Evidence: Urban Design Report
Name: John Lonink

22 May 2018
RMA/2017/1354

IN THE MATTER OF a Land use consent application RMA/2017/1354, 617-649 Colombo Street, Christchurch – Calder Stewart Development Limited C/- Urbis TPD Ltd

Figure a: The area in orange is where the full billboard will be visible and the area in yellow is where the billboard is partly obscured

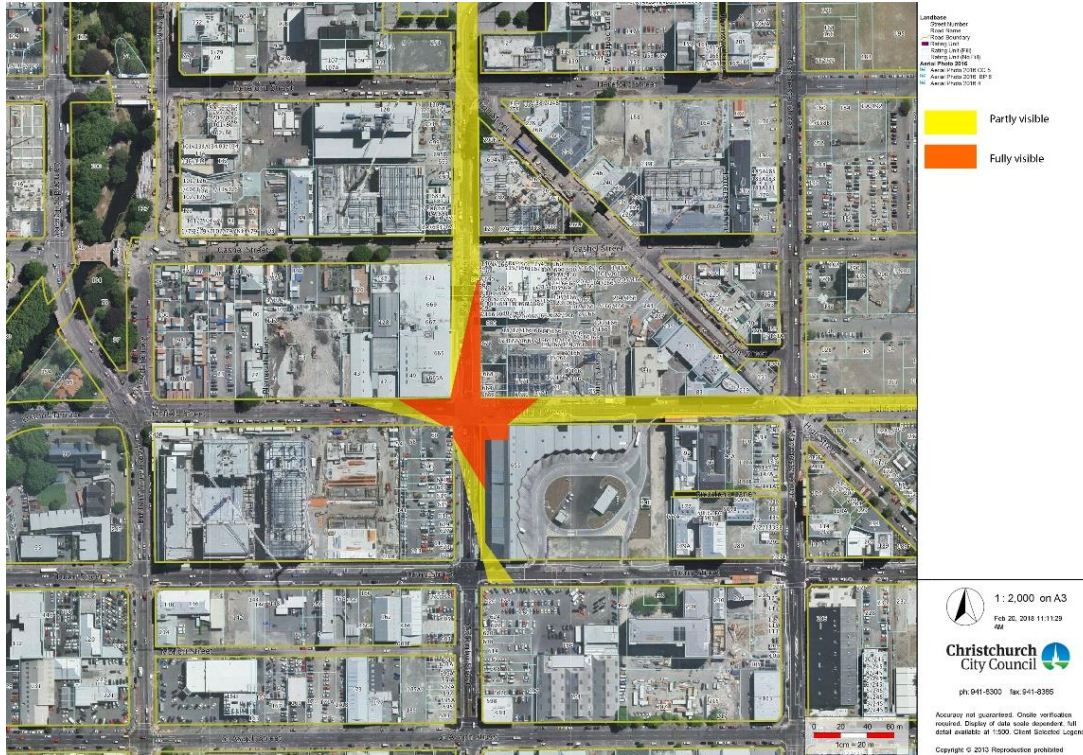
- 8.1. As can be seen on 'Figure a' above the estimated visual catchment area stretches from the intersection of Lichfield Street and Colombo Street predominantly towards the east and the north for a very long distance. In the section below a more specific estimate shows the possible viewing distance the screen could still be clearly seen from. The views from the west and south are more limited because the larger viewing angles will limit the effectiveness and visibility of the two screens.

photo locations for size and visual appearance comparison

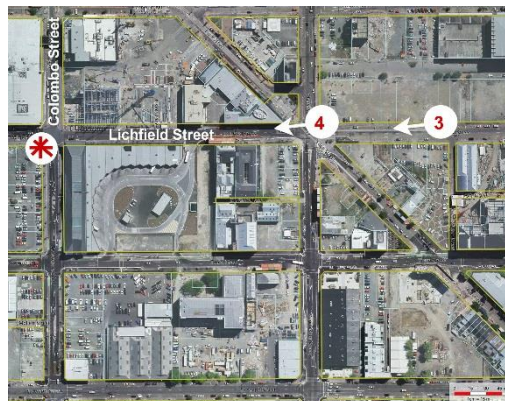
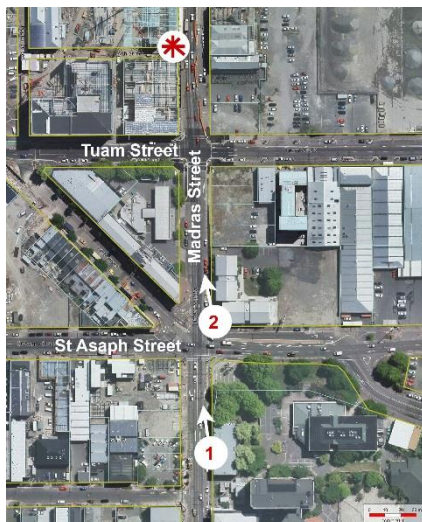
- 8.3. Below is a comparison of size and distance of views from Madras Street looking at the existing car park billboard (photo 1 and 2) and from Lichfield Street looking at the proposed cinema billboard (photo 3 and 4).

Location 1; Looking north from Madras Street. Roughly 250 meters away from the billboard. The text on the billboard can be read.

Location 3; Looking West from Lichfield Street. Roughly 375 meters away from the billboard. The billboard is of relatively similar size within this view so it is expected that text can be read.

Location 2; Looking north from Madras Street roughly 175 meters away from the billboard. Text can be easily read and the billboard is highly visible.

Location 4; Looking west from Lichfield Street roughly 265 meters away from the billboard. The billboard shows roughly the same size so messages can be just as easily read. The billboard is obscured by the roof of the bus interchange. This photo is taken exactly from the corner of the East frame as such a possible view for residential developments.

Modulation, articulation and architectural detailing of the cinema building.

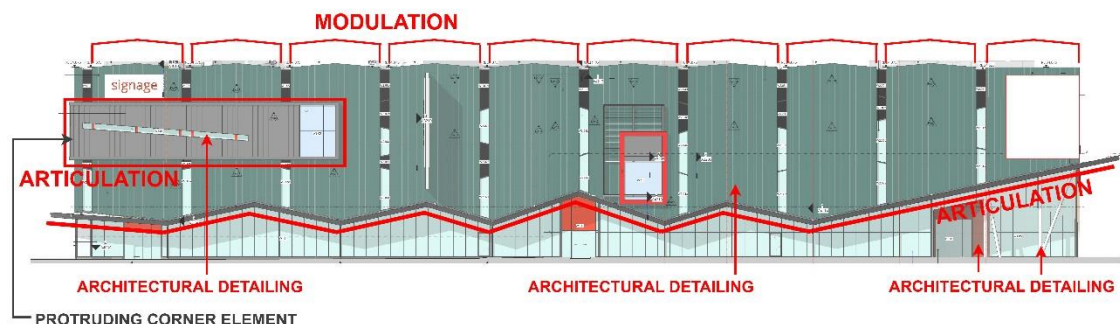
The cinema building is of a size and scale similar to the Bus Interchange building. As such it is not easily dominated by a LED billboard, even of such a size as is being proposed. However the sign does not integrate well with the architectural character of the building. Like the Bus Interchange, the scale of the cinema building has been broken down by modulating the build form and using articulation and architectural detail:

To modulate the main build form the cinema building uses an alternating roof form and a finer grain of façade modules. It will achieve a sense of vertical alignment by dividing these façade panels with vertically aligned glass panelling. Additional articulation, modulation and architectural detailing is achieved through the introduction of more horizontally orientated volumes and through variety in the façade materials.

Although the billboard does not dominate the building it is not integrated into the façade very well. Currently the sign almost, but not completely covers the two façade sections it is mounted on. This and the fact that the billboard will protrude about 0.7 meter from the façade will give the impression that the sign was more of an afterthought than the conscious design decision it is. A better composition would be able to be created if the billboard was smaller and of a similar height as the protruding corner element that wraps along the façade on the Tuam Street and Colombo Street corner. This element also has more architectural detailing and framing that can be used to integrate the sign better with the building design. The type of signage (off-site) that is proposed will most likely not contribute but rather detract from the uses inside and potentially the character of the building.

13.5. As a first amendment to the consent I would suggest the applicant significantly reduces the size of the screen. A similar height as the volume that wraps around the south East corner of the building while keeping the same width could be a guideline.

13.8. The screen needs to integrate with the architecture of the building. A similar solution could be suggested as has been used for the other volumes that protrude from the façade of the building.

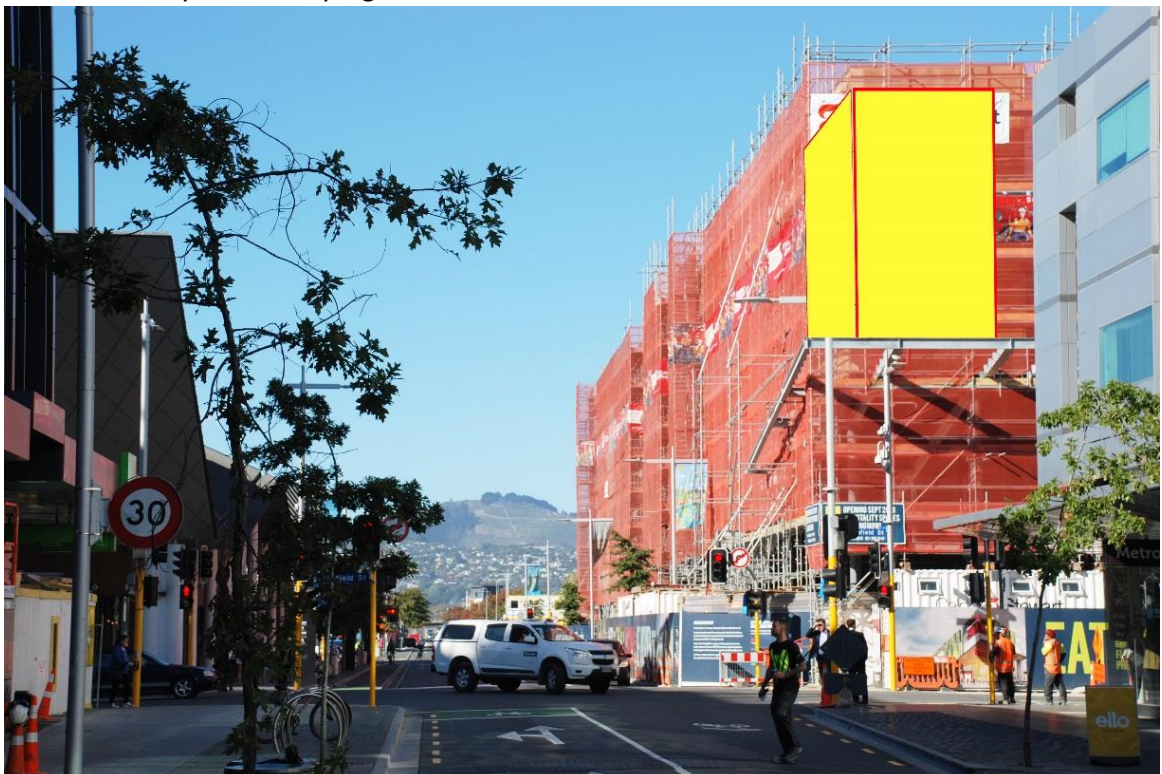
- 11.3. This photo is taken approximately 70 meters from the sign. The sign is still the most dominant element within this view.
This area is becoming a high quality pedestrian area and as such the effects of the sign would be significant.

- 11.4. This photo shows that the roof of the Bus Interchange obscures part of the sign.
During the day this will most likely reduce the visual effects of the sign. However at night the screen with moving imagery will still draw attention.
